AGENDA

MILWAUKIE PLANNING COMMISSION Tuesday May 11, 2010, 6:30 PM

**CITY OF MILWAUKIE
PLANNING COMMISSION
MINUTES
Milwaukie City Hall
10722 SE Main Street
TUESDAY, March 23, 2010
6:30 PM**

Fig 4A
JOB NO. MAEX0000018

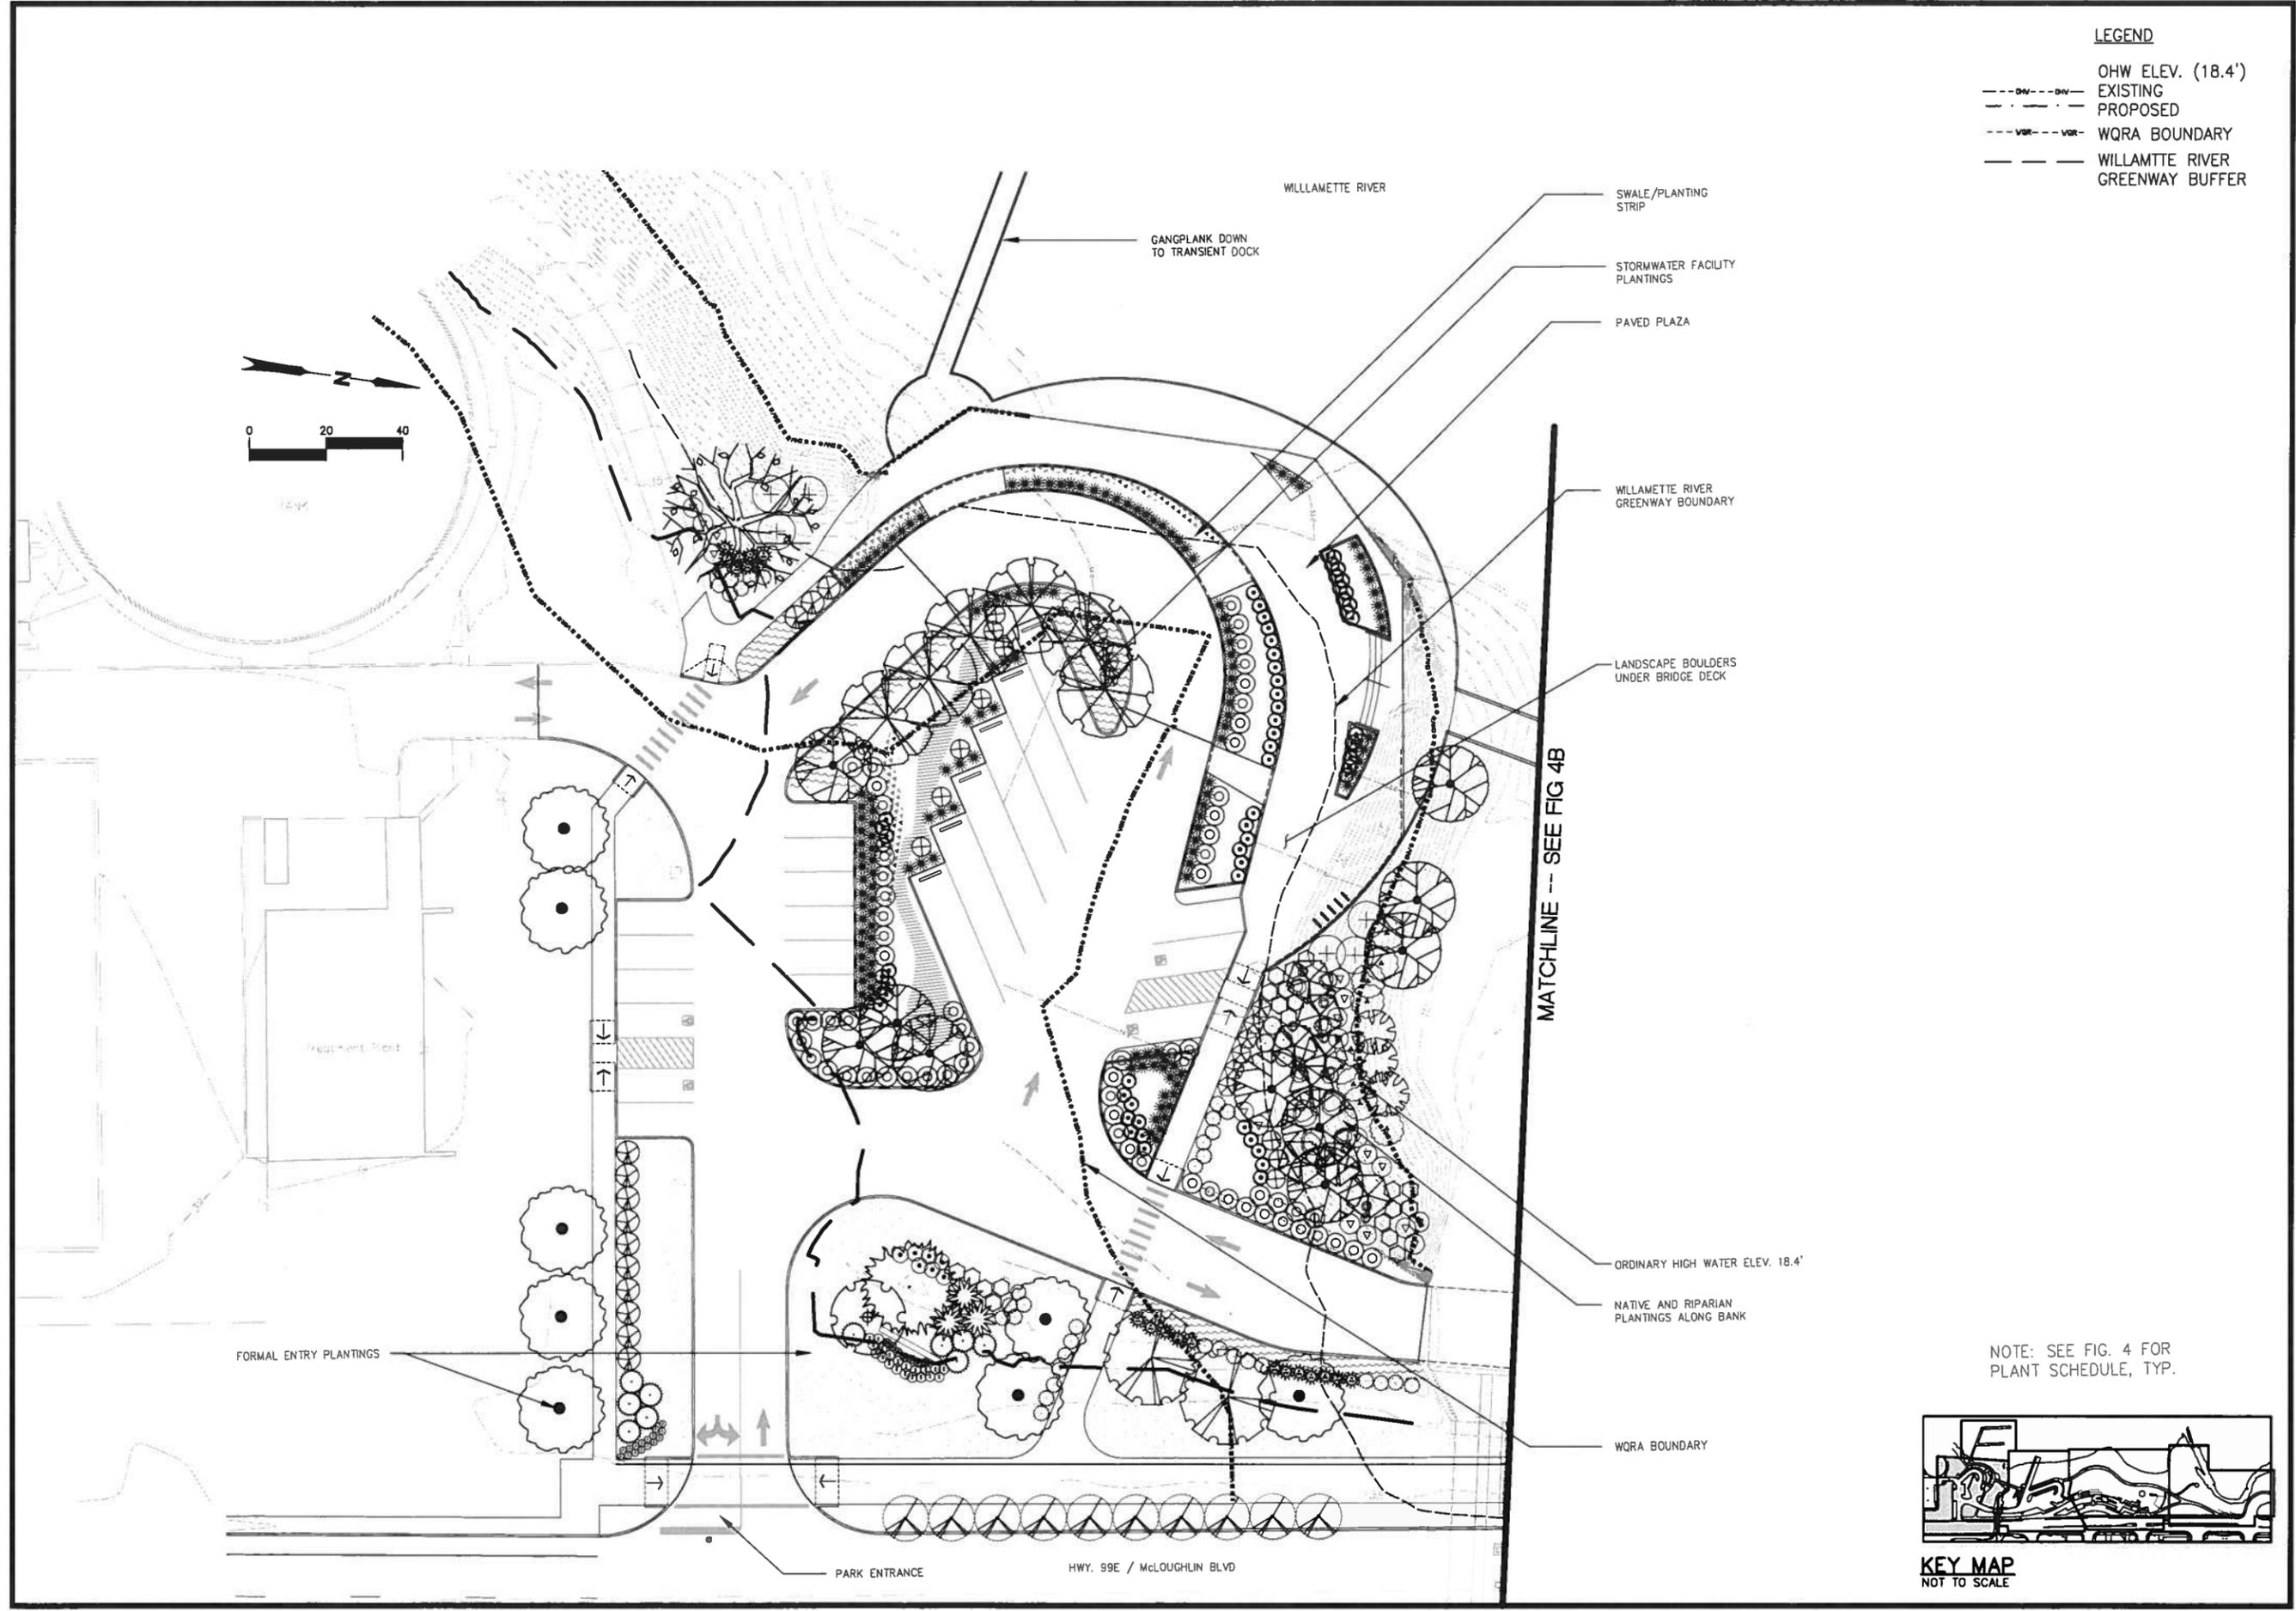
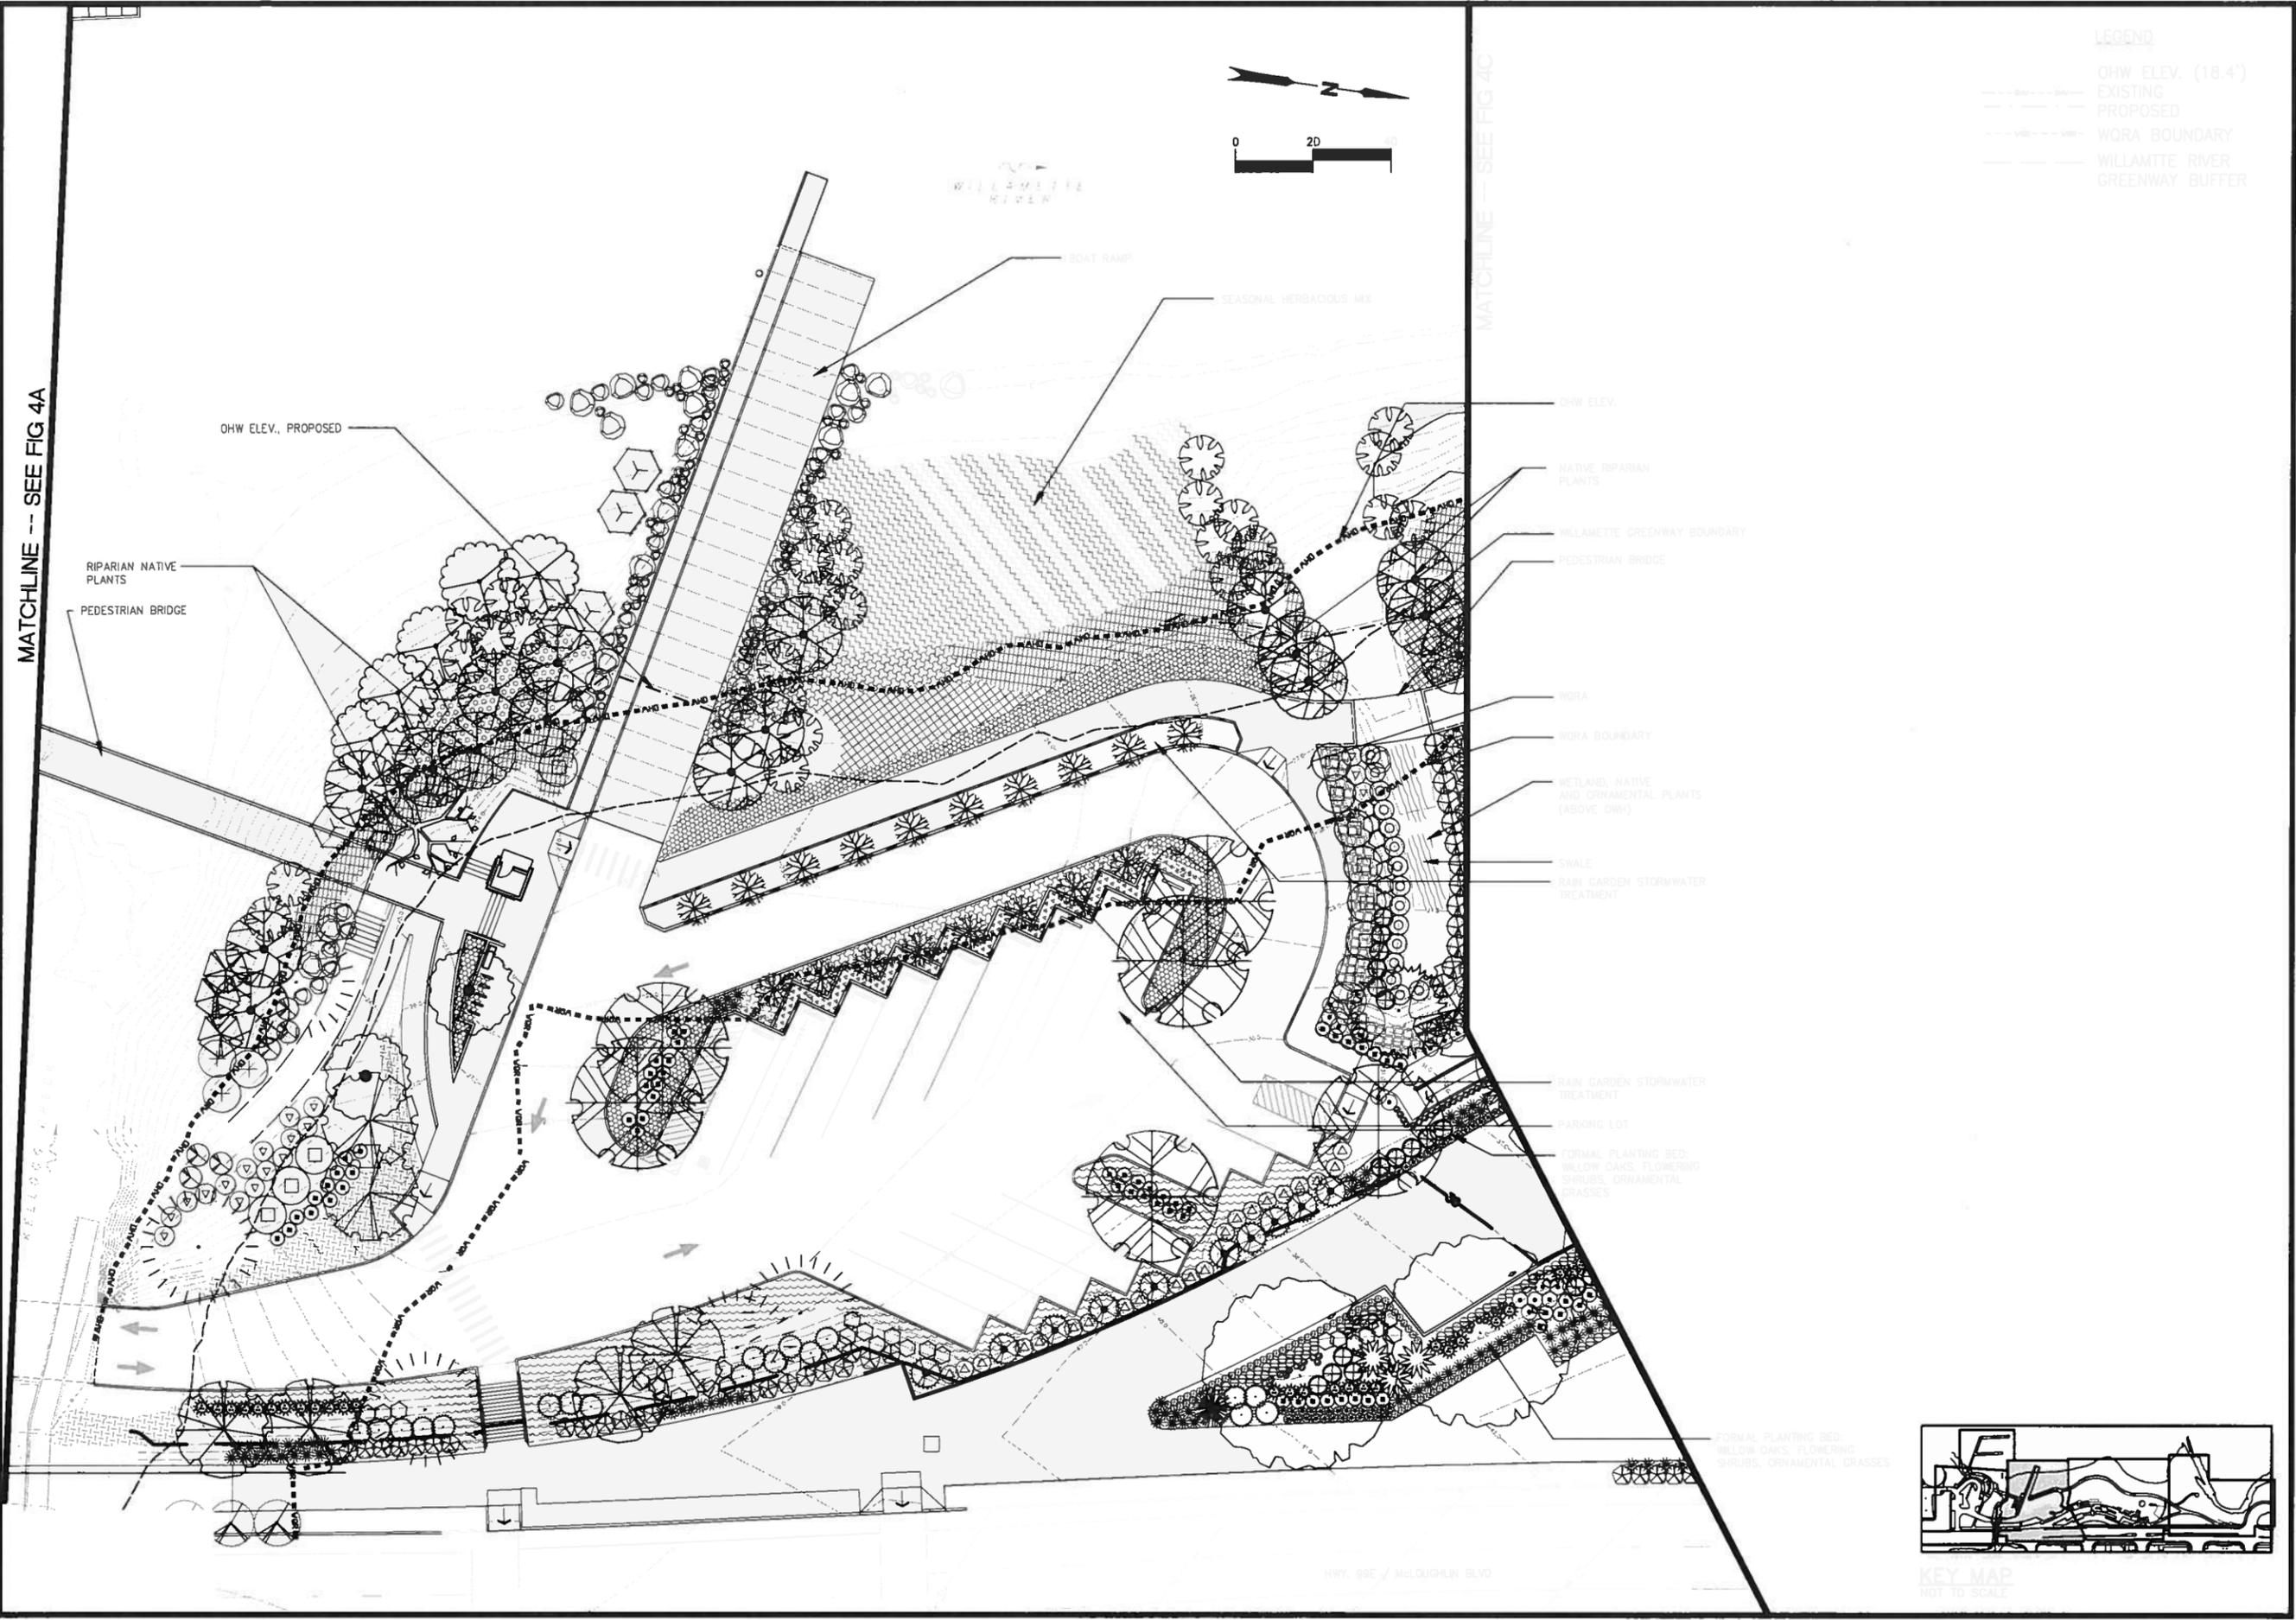
- C. Sufficiently addressed.
- D. Debris and noxious materials are adequately described in the application and are shown on a combination of plan views and profiles (Figures 4A, 4C, and 5C – although submerged debris reported to be below the sheet pile wall is not shown). Showing all debris and noxious materials on one plan view with the WQRA boundaries identified would be helpful.
